SITE INSTRUCTION

PROJECT: HAMPTON MANOR
25 BAKER HILL BLVD
STOUFFVILLE, ONTARIO

SITE INSTRUCTION: M-4

Purpose: Revised combined suite to suit architectural new layout.

DRAWN GC	CHECKED BT	SCALE 1:100
DATE JUNE 2015	PROJECT 14-016	DRAWING M-10 OF 42

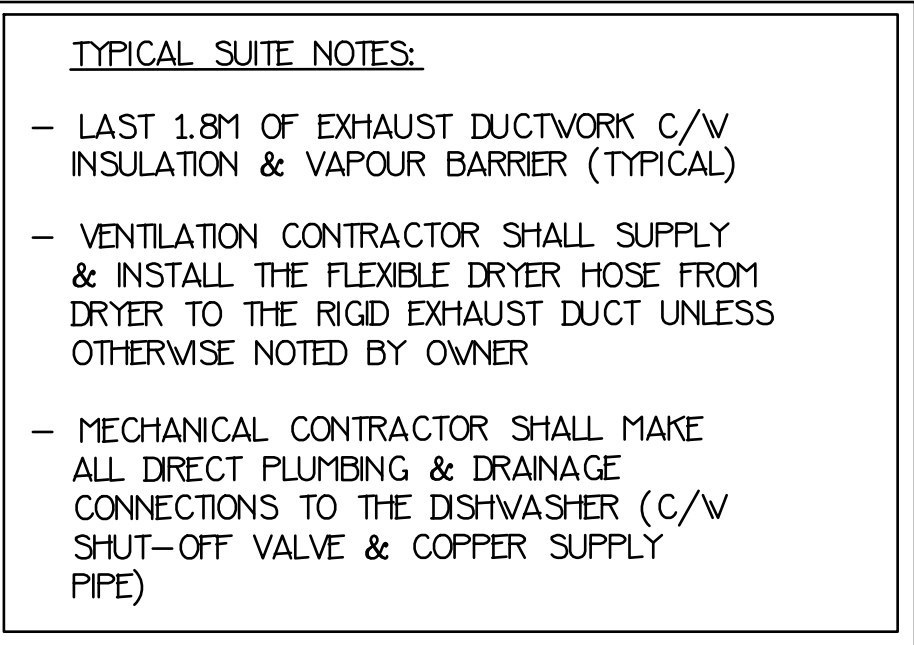
1.0 Reference Drawing M-10, M-12, M-13 (2nd Floor Plan) Issued

1.1 Revised: Mechanical layout.

DRAWN GC	CHECKED BT	SCALE 1:100
DATE JUNE 2015	PROJECT 14-016	DRAWING M-15 OF 42

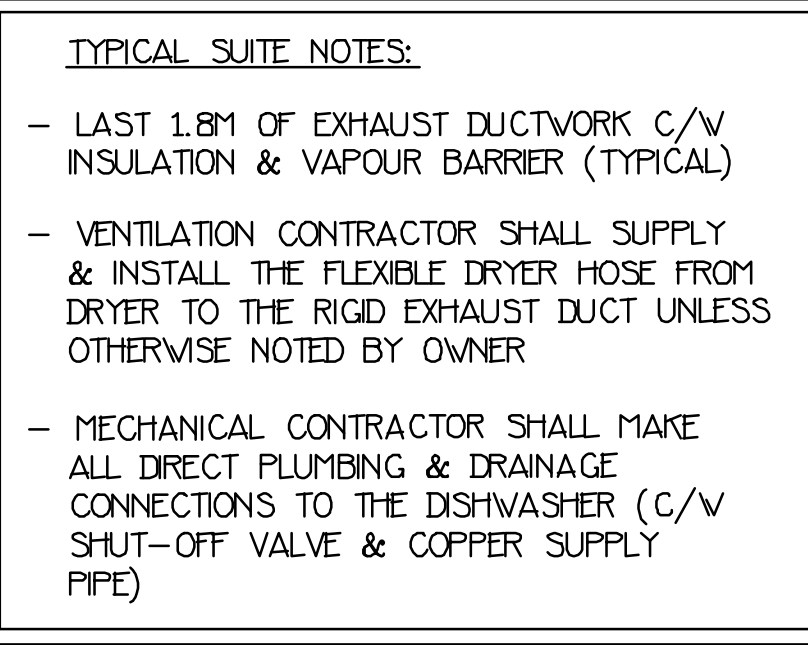
2.0 Reference Drawing M-15, M-17, M-18 (3rd & 4th Floor Plan) Issued

2.1 Revised: Mechanical layout.

TITLE		PROJECT	
PLUMBING RISERS		25 BAKER HILL BLVD.	
MECHANICAL		ROYAL PINE HOMES	
STOUFFVILLE, ONTARIO		PROPOSED RESIDENTIAL DEVELOPMENT	
DRAWN	GC	CHECKED	BT
DATE	JUNE 2015	PROJECT	14-016
SCALE	NTS	DRAWING	M-37
OF	42

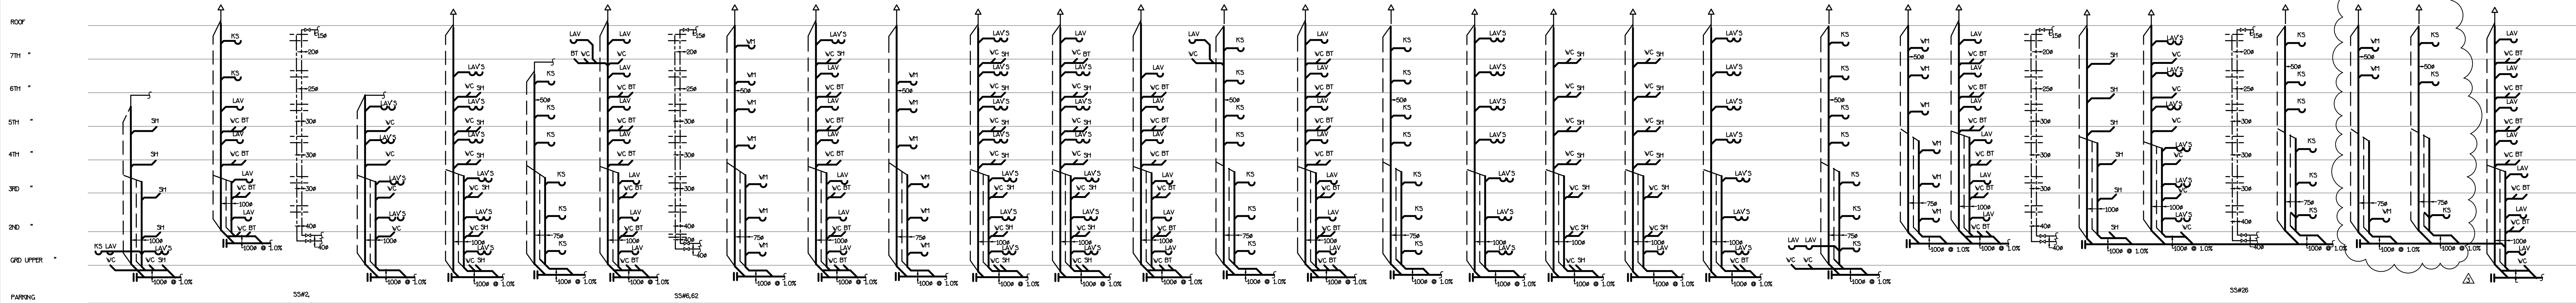
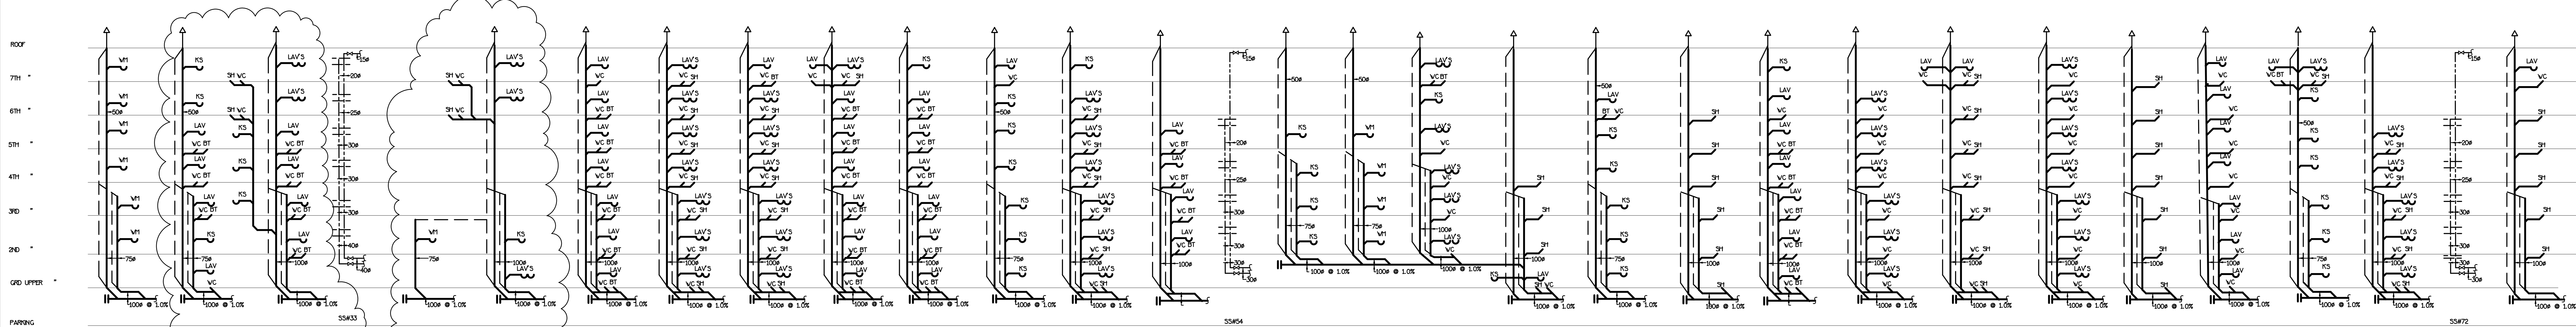
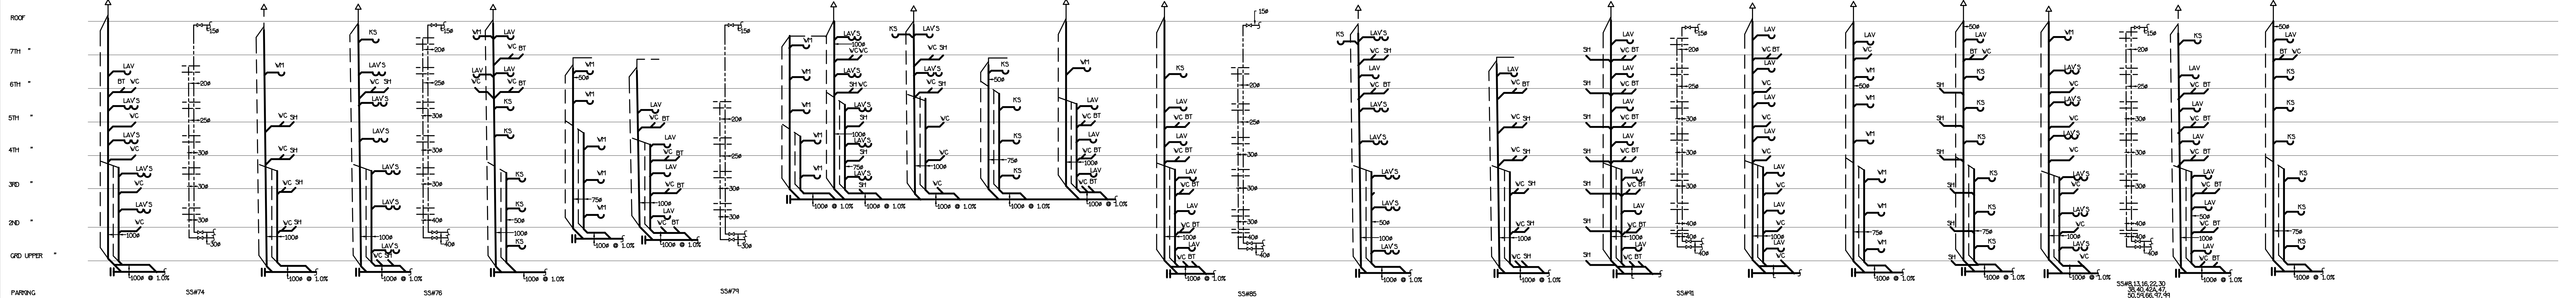
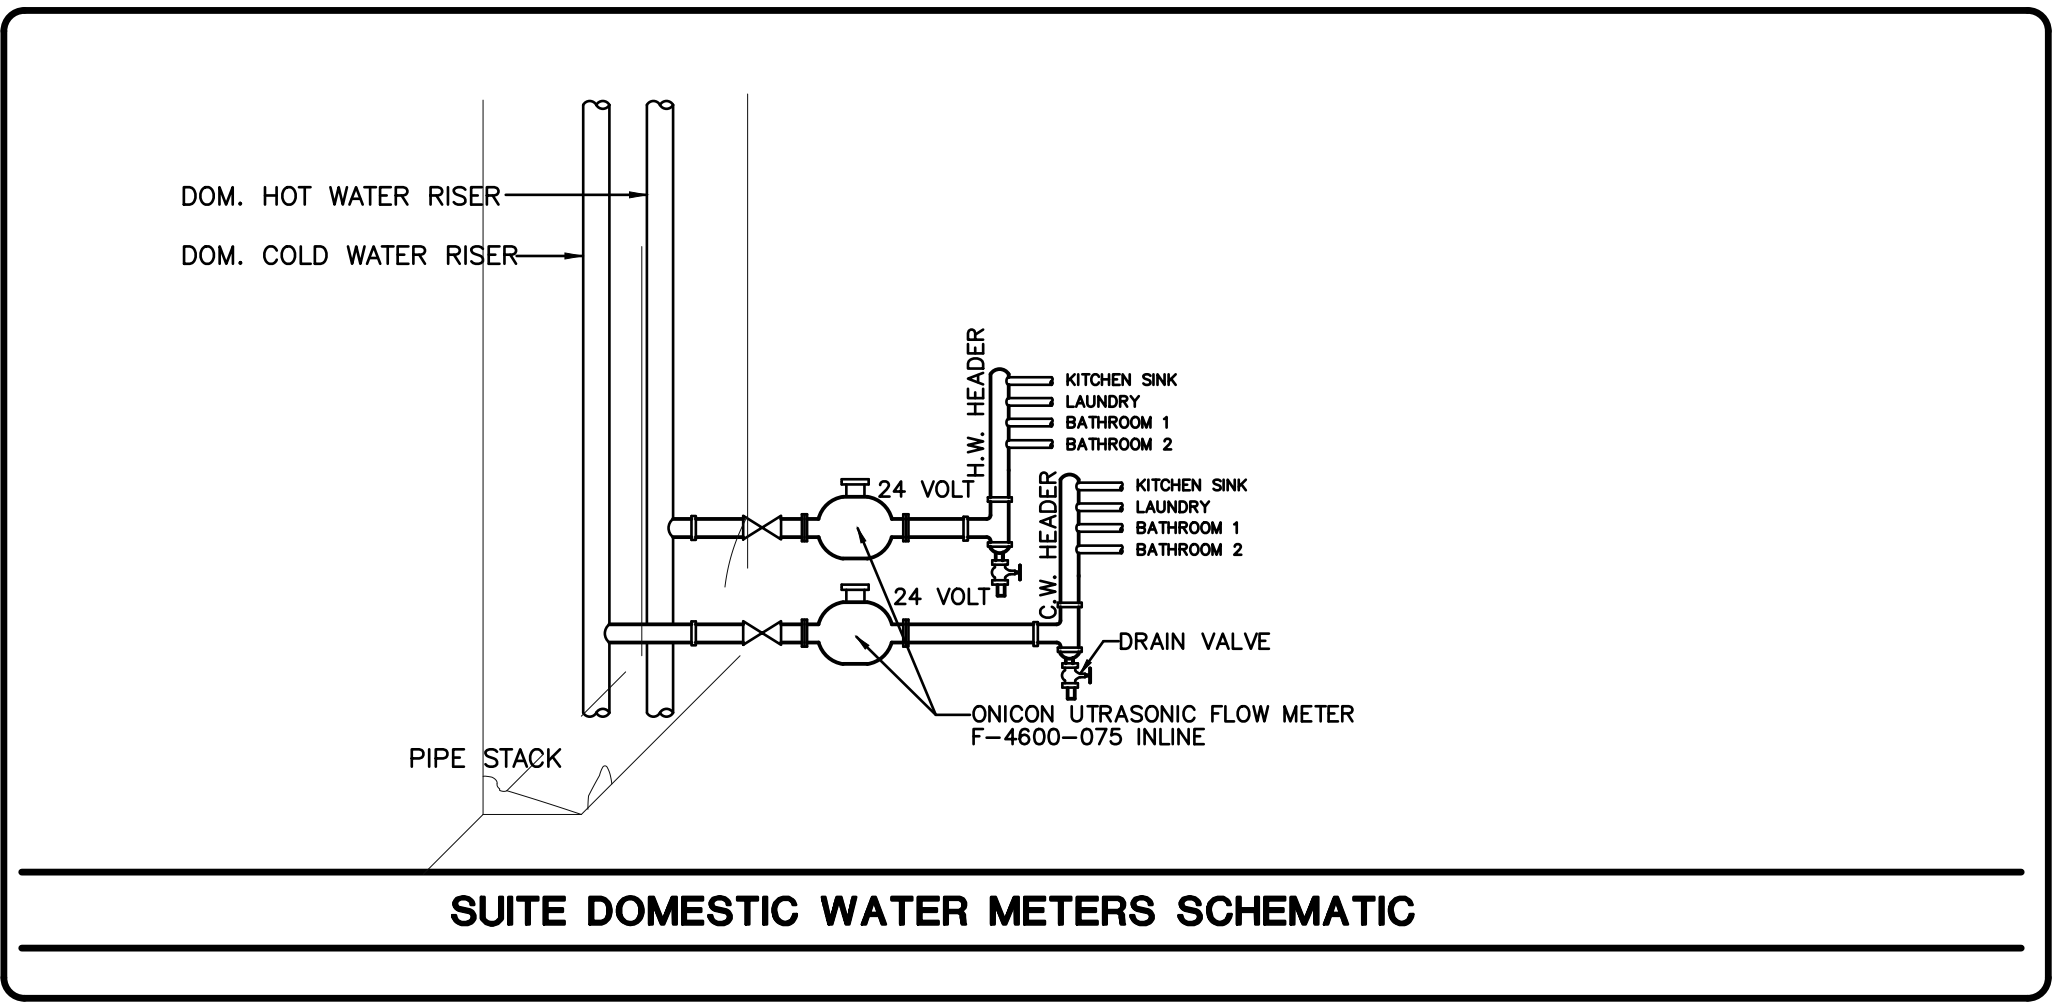
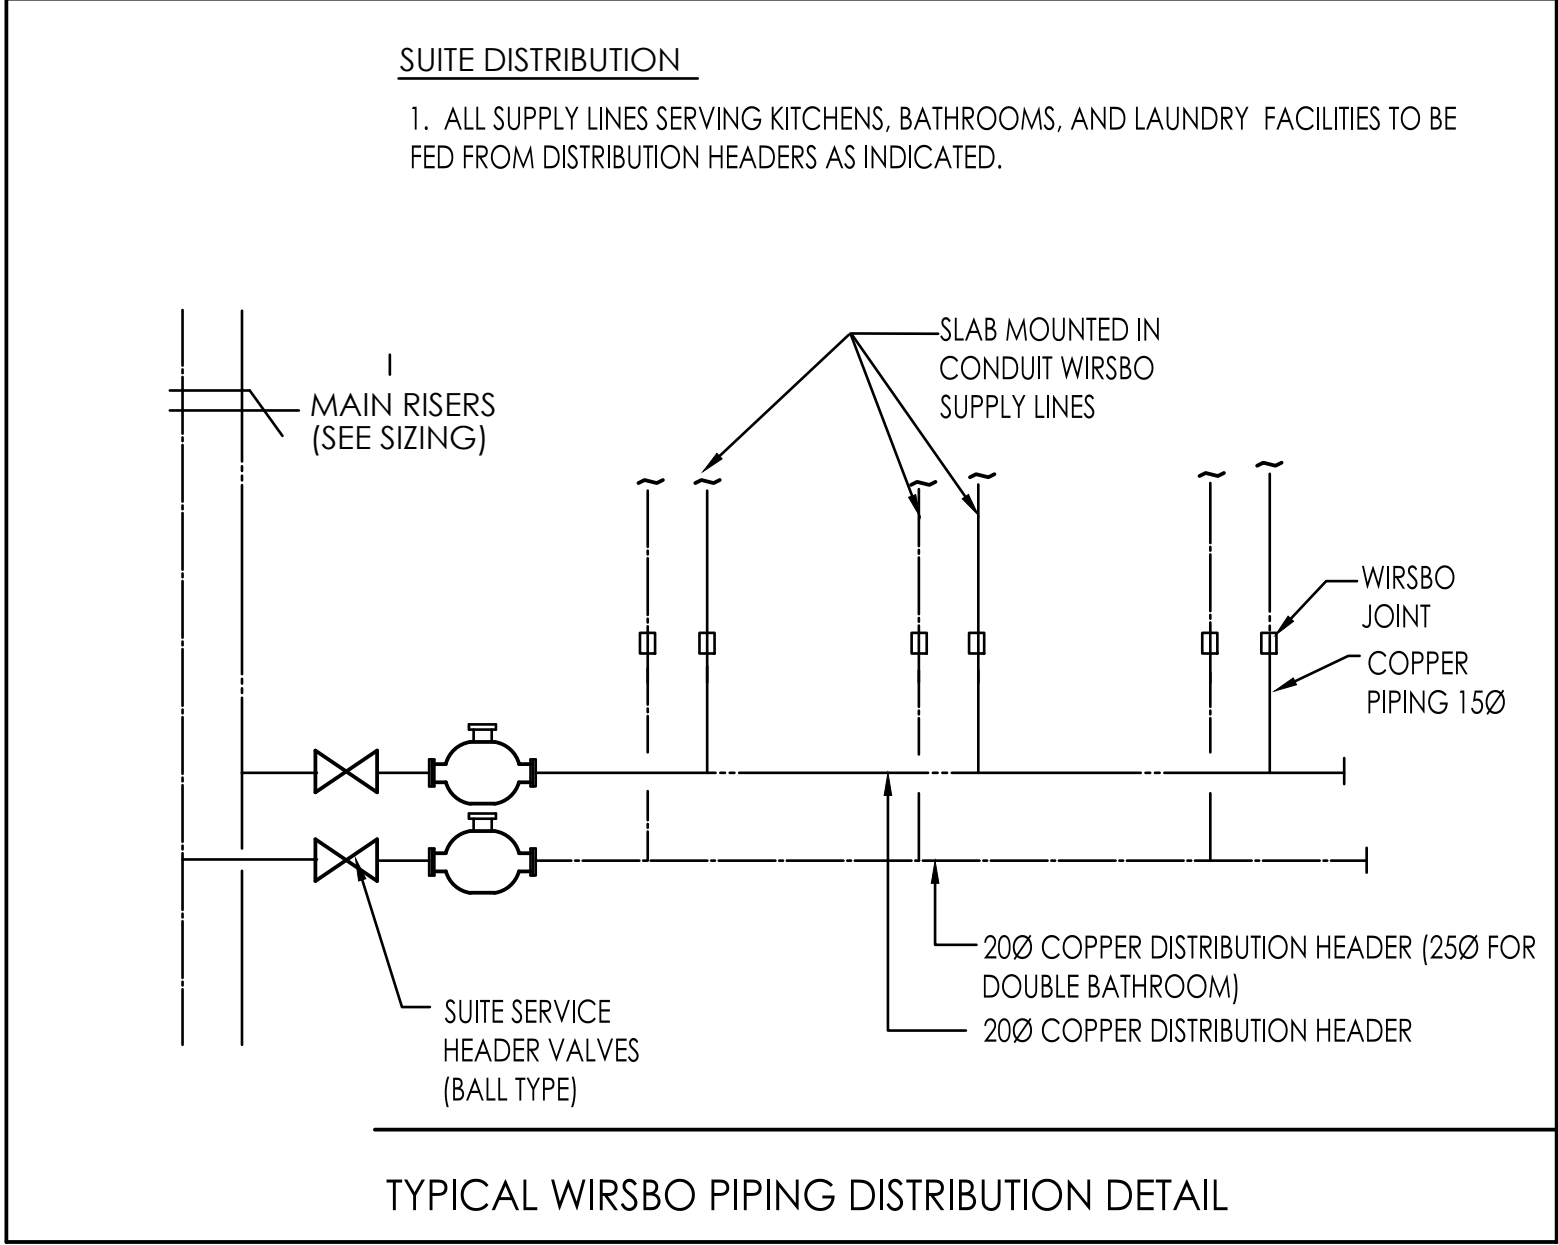
4.0 Reference Drawing M-37 (Plumbing Riser) Issued

4.1 Revised: Plumbing riser to suit new architectural layout.
